The ARAMARK Tower
1101 Market Street
Philadelphia, Pennsylvania 19107-2994

August 2, 2012

On behalf of the Philadelphia Water Department (PWD), I wanted to thank you and your colleagues at the PADEP for taking the time to meet with us on June 14 to discuss your comments submitted June 6, 2012 on our Implementation and Adaptive Management Plan (IAMP) submittal.

David Burke's Comments

Green City, Clean Waters Program Tracking System – “The Hub”

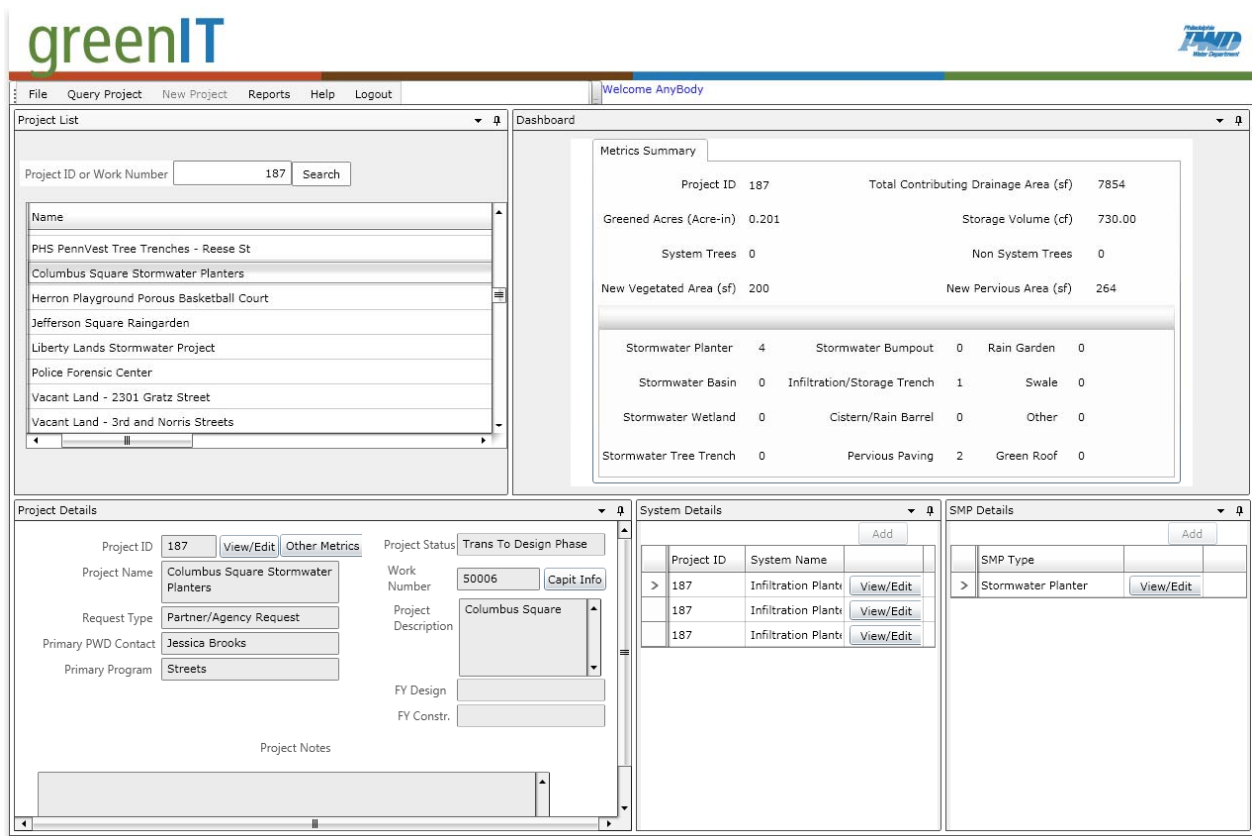
1. Section 2.1.1 (“Tracking System Development”) contains a brief discussion of the Interim Tracking System and the Green City Clean Waters Program Tracking System (“GCCW System”). DEP requests that the City provide a more detailed schedule for the completion and implementation of the GCCW System. The language in this section implies that the system may not be completed until the fifth year of the program, and this implied time frame gives DEP some concern. We request Philadelphia Water Department’s (“PWD”) explanation of why this task is extended over such a long time, as well as a discussion of how PWD intends to handle the transition from using the Interim Tracking System to using the GCCW System.

As described in the IAMP, the Water Department already has a number of robust data tracking systems in place and being utilized. What is planned is the integration of these existing data tracking systems through the creation of a *Green City, Clean Waters* Program Tracking System “hub” as a means of simplifying the compilation of information from these various systems for improved information dissemination and regulatory reporting. On page 2-2 of the IAMP, the following figure illustrated PWD’s vision for linking project tracking information.

In the months since the IAMP was submitted, PWD initiated updates to some of these systems to enhance their ability to track data and prepare for the development of the Green City, Clean Waters “hub”. This has resulted in an evolved graphical representation of PWD’s vision for the master

tracking system. Highlighted with a red outline in the graphic below are sub-elements to the tracking process that have seen significant progress in the past few months.
